#31 ZON2007-01771

PLANNED UNIT DEVELOPMENT

STAFF REPORT Date: July 19, 2007

DEVELOPMENT NAME Mikell Taylor

SITE PLAN

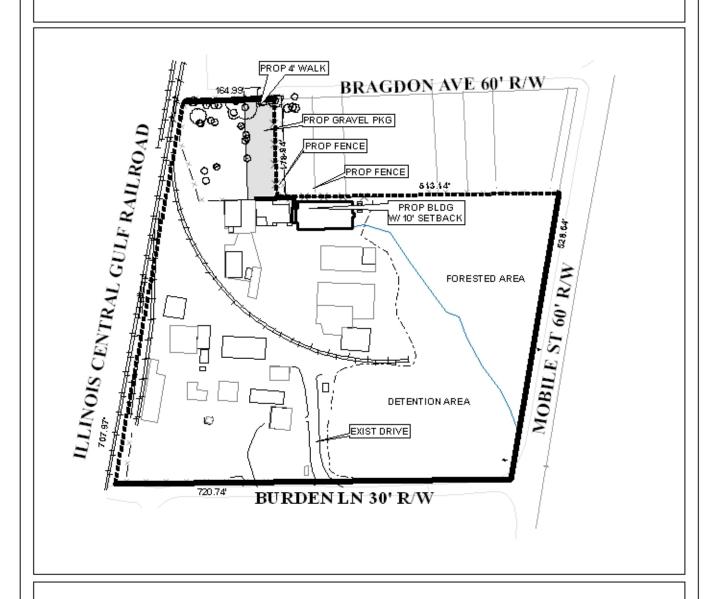
The plan illustrates the existing and proposed buildings, landscaping and green area, and 34 parking spaces on an aggregate surface.

Typically, aggregate would be allowed for laydown purposes such as pipe storage, and/or heavy machinery storage area. However, since this area is for vehicular parking, since truck access is prohibited from Bragdon Avenue, aggregate is not an approved parking surface. Therefore, the parking surface should be concrete, asphalt or an approved alternative paving surface.

RECOMMENDATION Based on the preceding, this application is recommended for denial.
